DSPC response to MRCS Initial Review of the DSHPP

Prepared by Mega First Corporation Berhad
For Don Sahong Power Company
6th March 2014
Revised September 2014

Figure 1. Natural and developed flows in channels modified to improve migration pathway

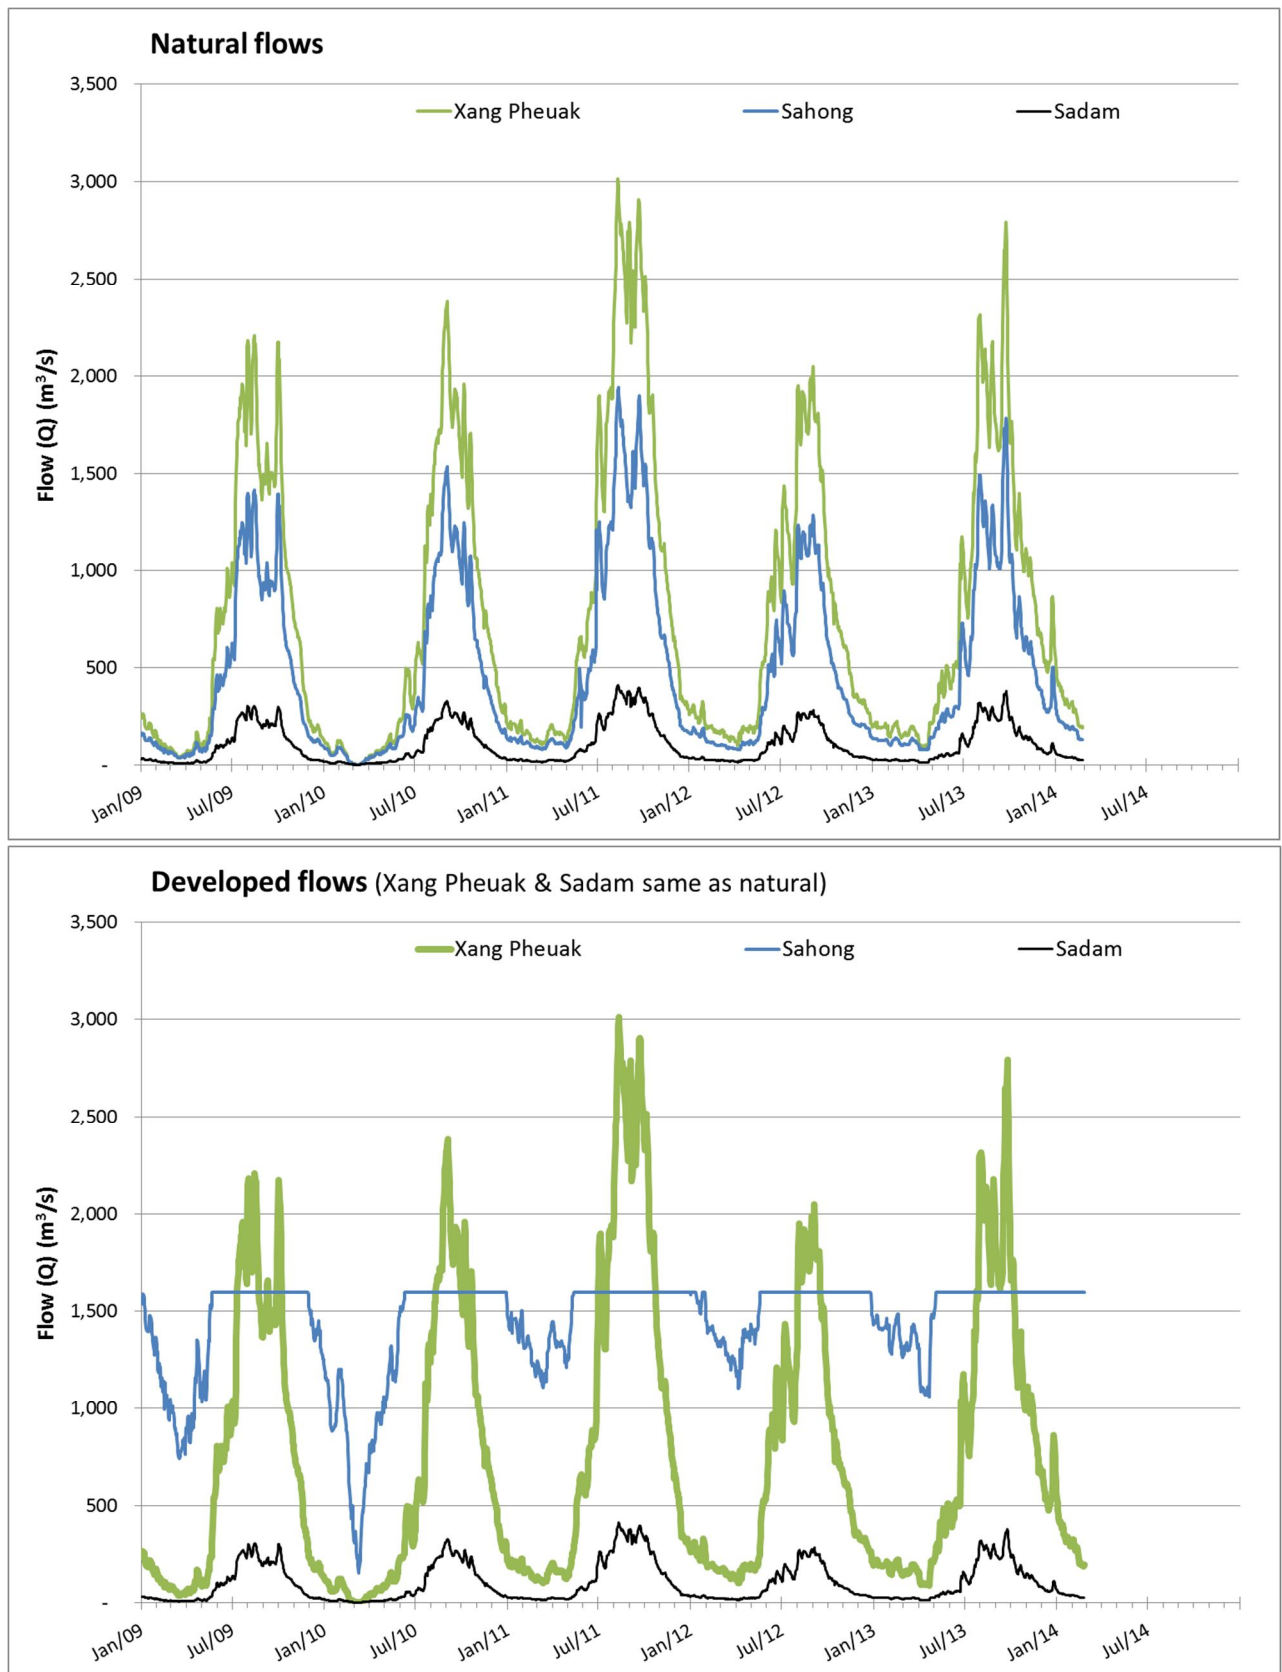
11. *EIA report does not provide information on average monthly water flows of pre-dam and post-dam situation of Hou Sadam and Hou Xang Pueak and other channels that are supposed to absorb all the fish migration movements including those disabled by Hou Sahong dam.*

This information is available in the engineering reports (AECOM 2011, AECOM 2011, SMEC 2012, SMEC 2013). Daily actual and predicted post development flows for past 5 years are presented below.

Figure 2. Attraction flow from Hou Xang Pheuak at Sahong Junction (2009-2013)

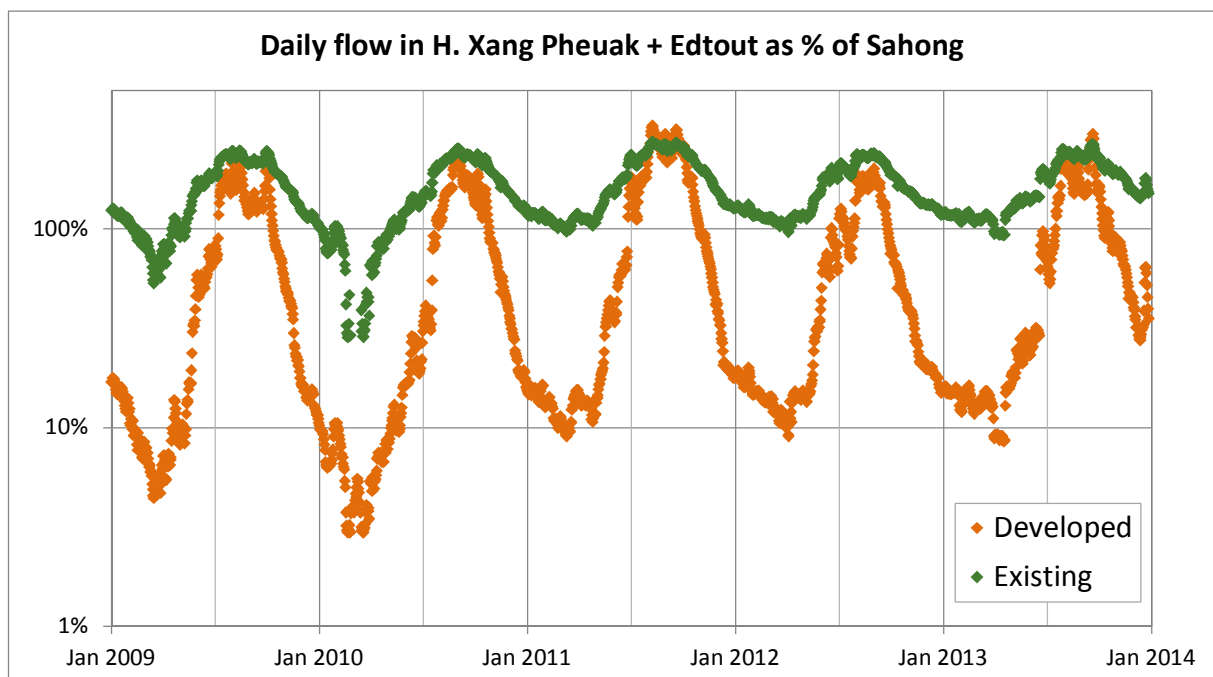
16. Adequate flows must be directed through the fishways to ensure they function effectively in both the high and low flow seasons, and at all times are sufficient to ensure optimal effectiveness for fish passage targets (PDG,2009). “To provide sufficient attraction for migrating fish, effective upstream fish passage on the mainstream Mekong River would need to pass 10% (100 m³/s) of low flows and 1% (230 m³/s) of the maximum design flow” (Xayaburi Prior Consultation Review Report, MRC 2011).

Targeted clearing, shaping and excavation works are being carried out within the Hou Xang Pheuak to encourage fish migration. These works will be extended to ensure that dry season flows through Hou Xang Pheuak will not be reduced by scheme operation. The modelled daily flows through Hou Xang Pheuak (and adjoining Edtout channel) as a percentage of Hou Sahong discharge are shown in Figure 2.

The attraction flow in Xang Pheuak at the Sahong confluence (Q Xang Pheuak + Q Ee Doot) will almost always be more than 10% of the Sahong flow. The Developer plans channel modification (illustrated in Pakse meeting March 2014) to focus and improve this attraction flow near the Sahong confluence.

The figure is based on reported daily Mekong flows of 2009-2013. It is noted that 2010 dry season represented an extreme case (lowest river levels on record), and the observed flows of 2011 onward are more representative of expected future flows.

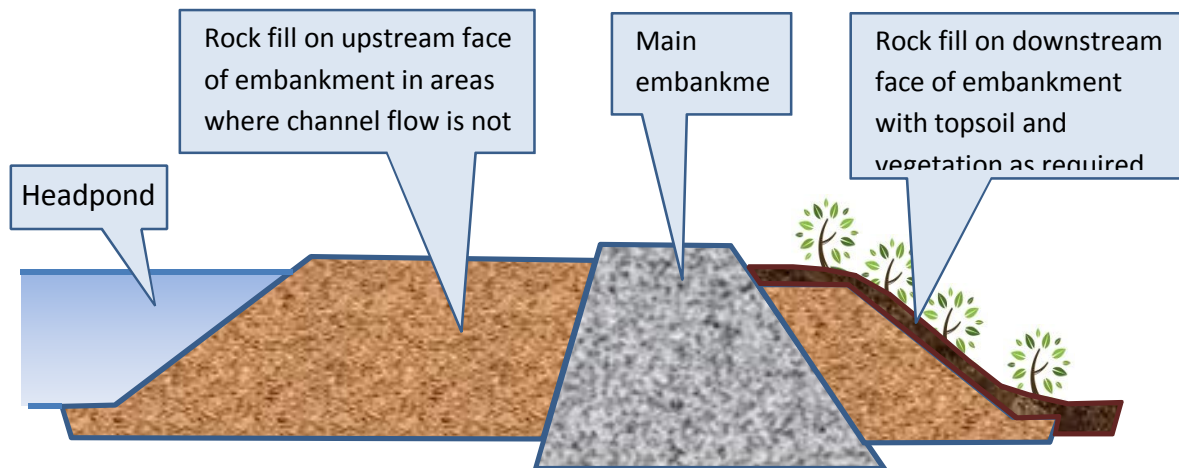
- ✓ Decision on minimum environmental flow should be targeted towards maintaining a sustainable balance between the purpose of the dam and the needs of the downstream ecosystems and resource users.
- ✓ Visual impact on the Falls is a primary consideration in establishing the minimum flow
- ✓ A flow of 800 m³/s satisfies the existing ecological and ecosystem demands, as the overall pool water volumes, deep-pool locations and depths, and water pathways in the affected reach are not significantly changed
- ✓ Economic effect of 600-800-1000 m³/s environmental flow has been assessed
- ✓ A flow of 800 m³/s is 28% of the mean and 32% of the median flow over the Falls, which is substantially higher than the “rule of thumb” of 10% that has traditionally been applied to other projects internationally.

It is relevant to note that the 2010 feasibility studies for the neighbouring Thakho project similarly adopted a minimum environmental flow of 800 m³/s over the Phapheng Falls. Documentation produced by the Thakho project does include a photograph of a reported flow of 980 m³/s over the falls (taken 5/3/10) – as below.
